1001 MINOR
DESIGN REVIEW BOARD

18 NOVEMBER 2015
DPD #3019363

PROJECT INFORMATION

ADDRESS: 1001 MINOR AVENUE

b. Facade Composition & Architectural Character. (CS3-A, DC2-A,B,&C, DC4-A)

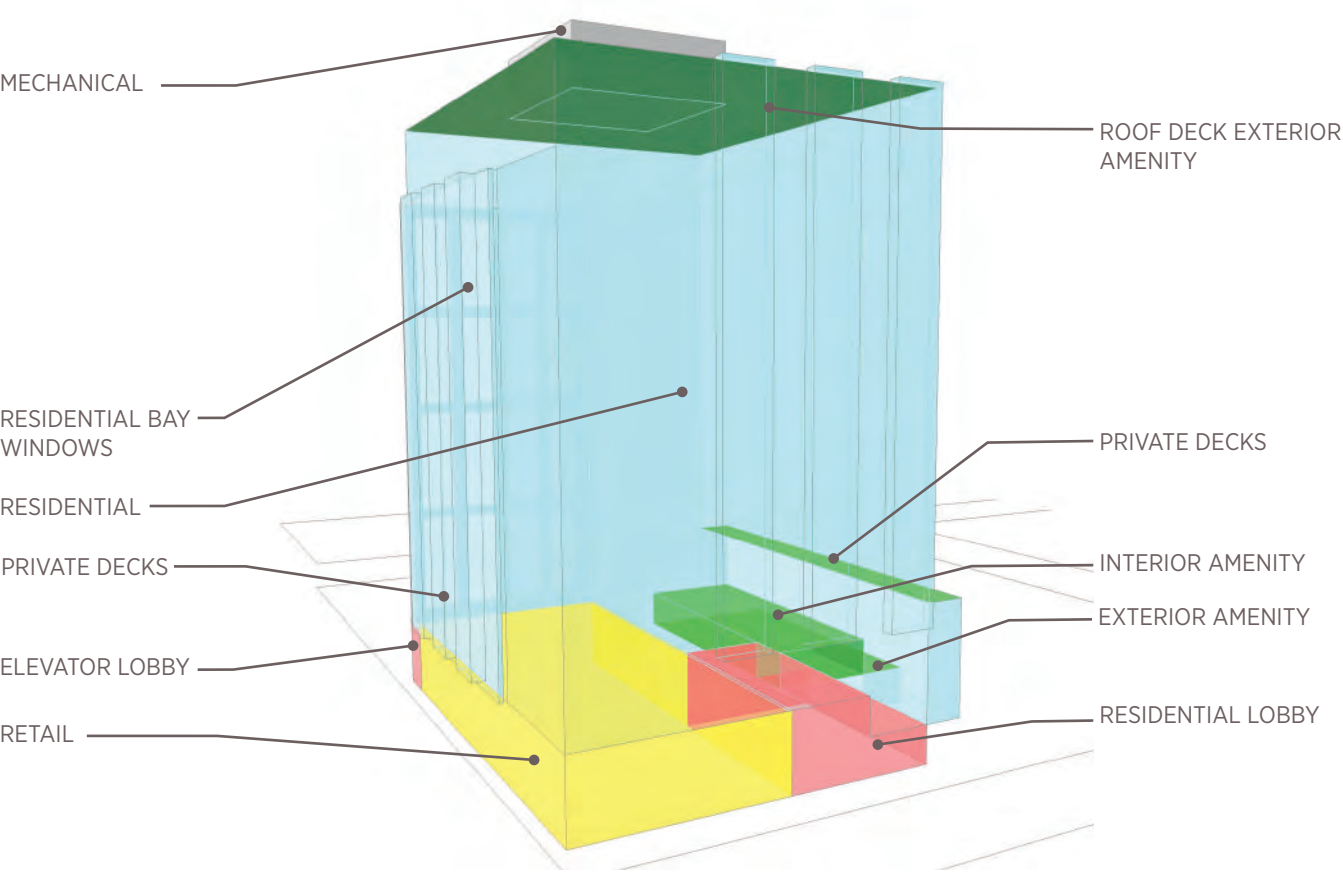
"The Board supported the residential character that was expressed in the vertical bays ... helping to distinguish the building's residential use and contrast to the institutional structures in the area."

"The Board also noted that the bays and corner modulation have potential to create an overly busy facade and directed the applicant to be mindful of maintaining a simplified composition when further refining the design."

While the residential vertical bays were supported by the Board they had some reservations about the complexity of the facade. This has been addressed by using a simple unified window wall design for the residential bays. The sleek window wall bays create a contrast against the dark brick massing, but complement the other larger areas of window wall. The building skin has been simplified to two

MADISON ST STREET LEVEL RENDERING

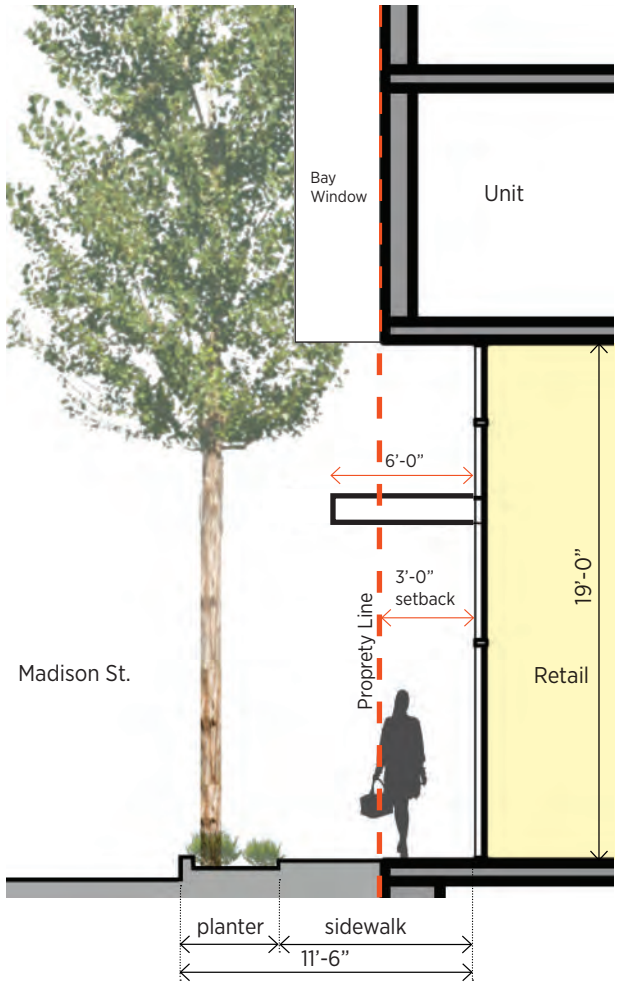
"The Board expressed general support for the configuration of the retail spaces in the applicant's preferred option along Madison St and recognized Madison St as a more business-oriented retail corridor."

"Design the retail spaces in a way that would attract more active and engaging tenants that would offer extended hours."

"The Board supported the generous 20 foot tall retail heights and directed the applicant to design the spaces to be flexible."

"Specific attention should be paid to the ground floor corner of Madison St and Minor Ave to ensure the corner is active and animated."

in response to the boards request to provide attractive active retail space. Madison has been designed to include:

- 19 vertical feet of retail height
- High transparency storefront
- Playful storefront design
- Metal canopy with a warm wood soffit
- 3'-0" set back allows for a 11'-6" wide sidewalk with planting strip at the outer sidewalk edge
- To provide options and flexibility the retail space can be occupied by up to three tenants. Three separate doors with direct street access along with flexible interior space provide a range of retail options.

STREET CORNER OF MADISON & MINOR

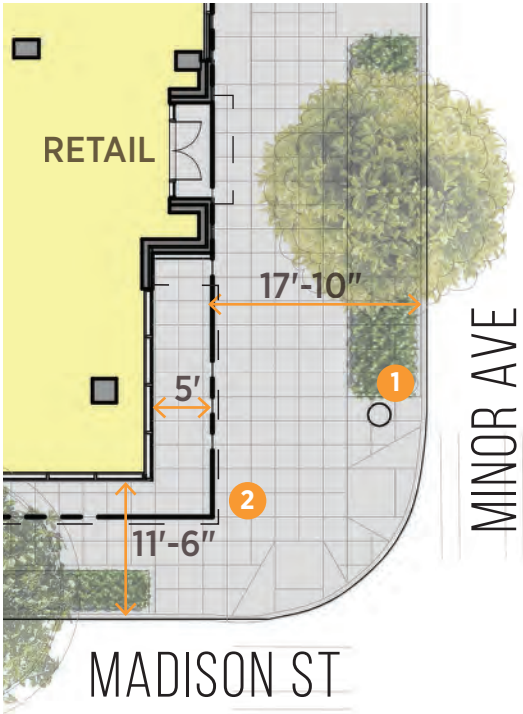
"Specific attention should be paid to the ground floor corner of Madison St and Minor Ave to ensure the corner is active and animated."

To respond to the Board's comments to activate the corner, the following elements have been designed:

- The canopy is raised by 2' at the corner to provide additional height and transparency
- The canopy and the accent wood material wraps around and responding to the street corner
- An additional 5' setback along Minor encourages retail spill out
- Bike racks activate the space and provide an amenity for retail customers

SW CORNER PLAN:

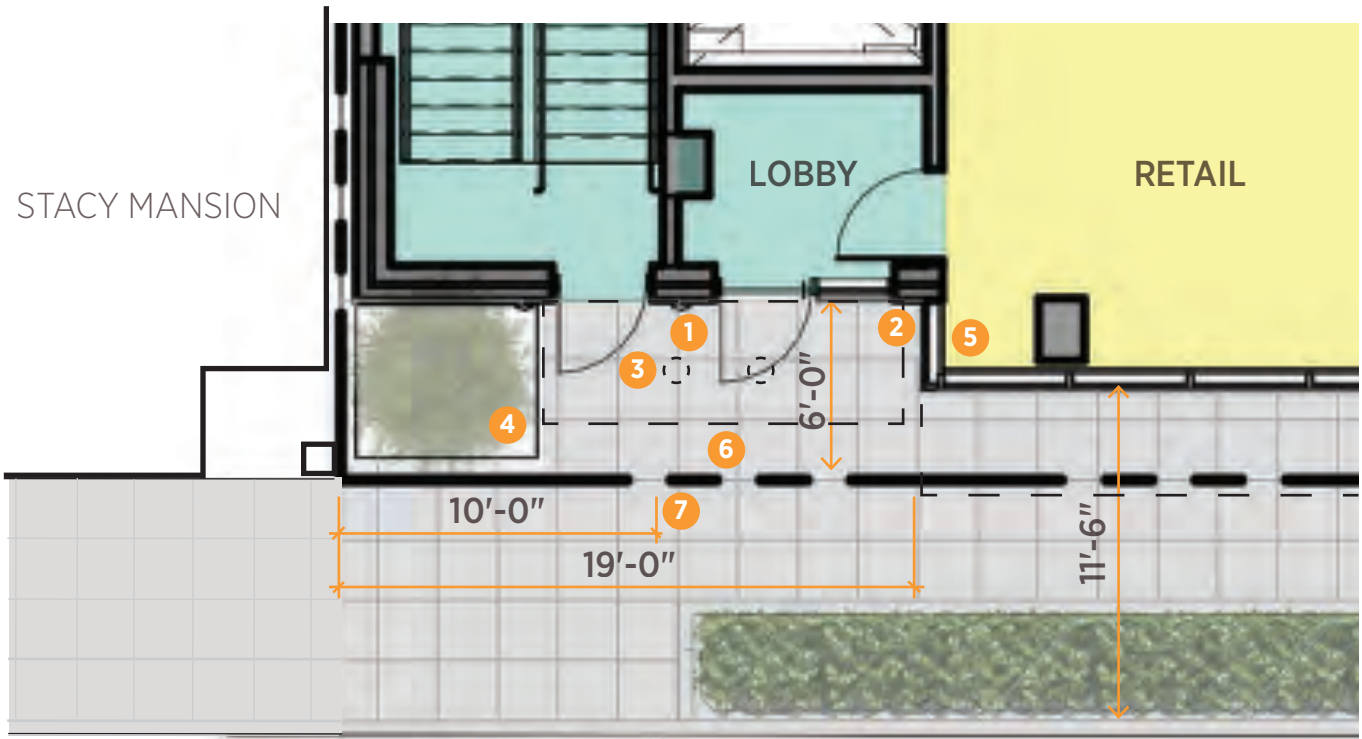
"The Board showed general support for the recessed ingress and egress are at ground floor adjacent to the Stacy Mansion on Madison St."

"Be mindful of safety and design this space to minimize potential for undesirable uses in this area such as transient camping."

To promote safety the following features have been added :

- 1 Secure garage access for residents - Lit 24 hrs
- 2 Security cameras
- 3 Recessed down lights at canopy above entries
- 4 Planter with steel edge and green screen trellis to discourage loitering
- 5 Eyes on the street from retail corner return, lobby & level 3 decks
- 6 Canopy for weather protection
- 7 10' upper level setback from Stacy mansion allows for eyes on Madison Street from decks above.

CURRENT LOBBY PLAN:

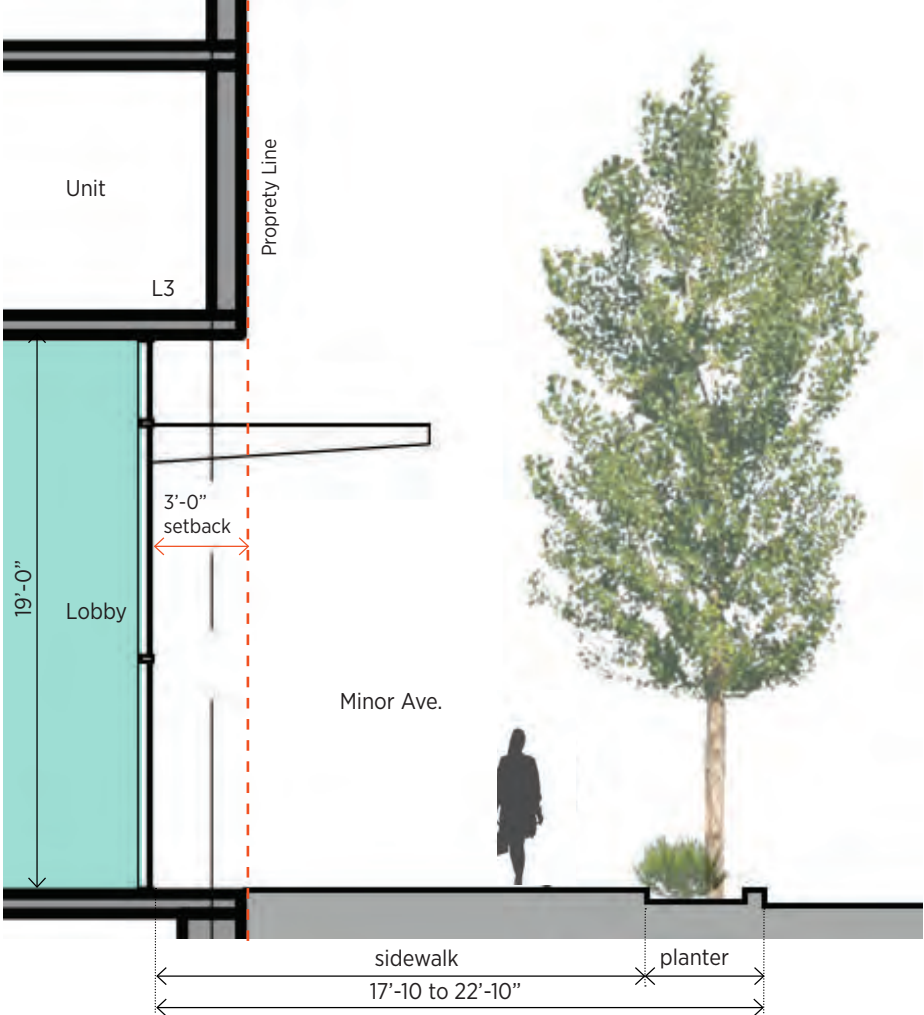
"The Board expressed concern with...location of the leasing space and residential lobby along minor ave... because of its potential to be an inactive space."

"Explore innovative and non-traditional layouts for the lobby and leasing area to make the space more active."

"May include...creating more permeability between the leasing and lobby space that would have potential to be more active during nonbusiness hours."

"The applicant should provide interior renderings of the leasing and lobby space, as well as additional detail on the layout and programing of these spaces."

The lobby and leasing area has been reprogrammed and redesigned since EDG to allocate more space to building common area and minimize the areas dedicated to leasing.

- 1 The first floor area north of the residential entry along Minor Ave is now lit and open to tenants 24 hours and cannot be locked off.
- 2 The dedicated leasing spaces are limited to one office and a small conference room inboard from the windows.
- 3 This new layout will allow for a more open and flowing common tenant area and the flexible seating and work stations will encourage active use.
- 4 The glass windows along the Minor and the entry drive with high transparency will facilitate eyes on the street.

VIEW FROM THE DECATUR

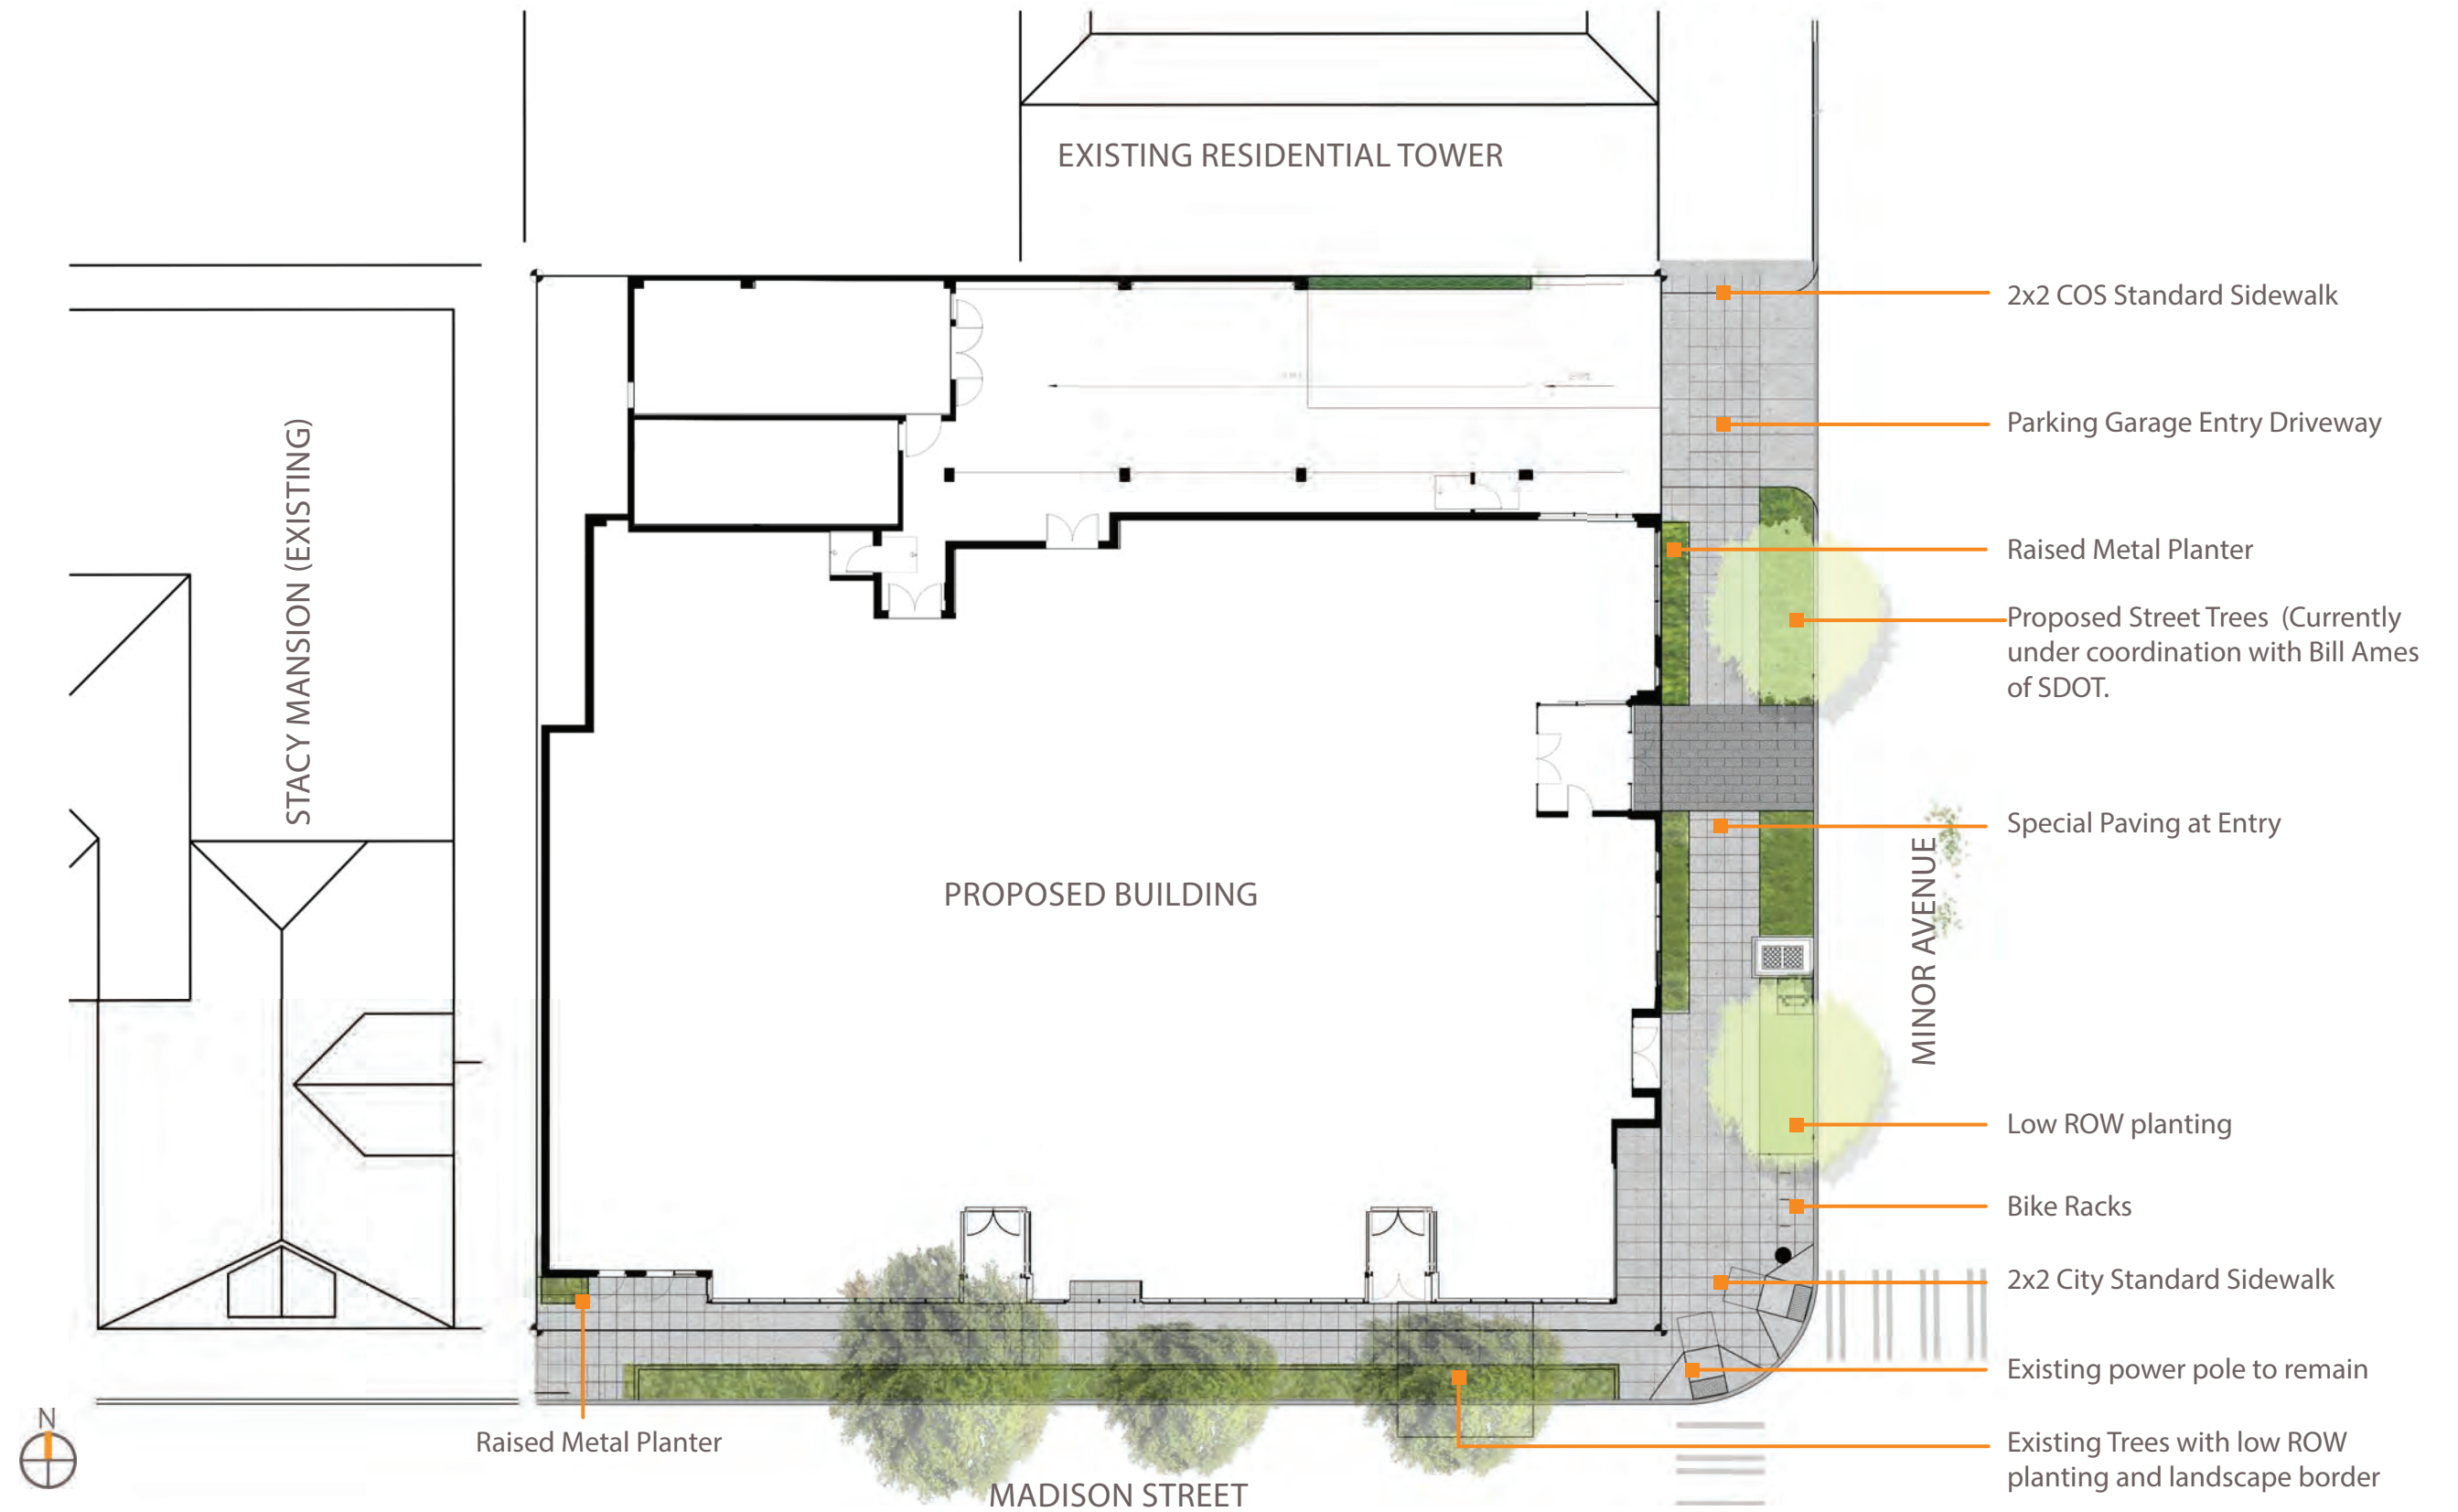
"The Board expressed general support for the location of the amenity spaces in the applicant's preferred option."

"Design the terraced outdoor amenity space on the second and fifth levels as garden-like settings...to ensure these spaces were viewed as greenspace, and not just hardscape, from the neighboring adjacent residential units."

"Provide additional details on the landscaping and layout of the amenity spaces, specifically the amenity spaces located on the second and fifth levels."

To respond to the Board's guidance regarding the outdoor amenity areas:

- Ample planting is provided at the common terrace at level 2 (see landscape plans on p.28 & 29)
- Green screen are provided at the common terrace edge at level 2 to maintain privacy
- Each private deck (level 3 & 5) is separated by generous planting dividers
- High quality materials (brick & window wall) are used to clad the massing at the terrace level
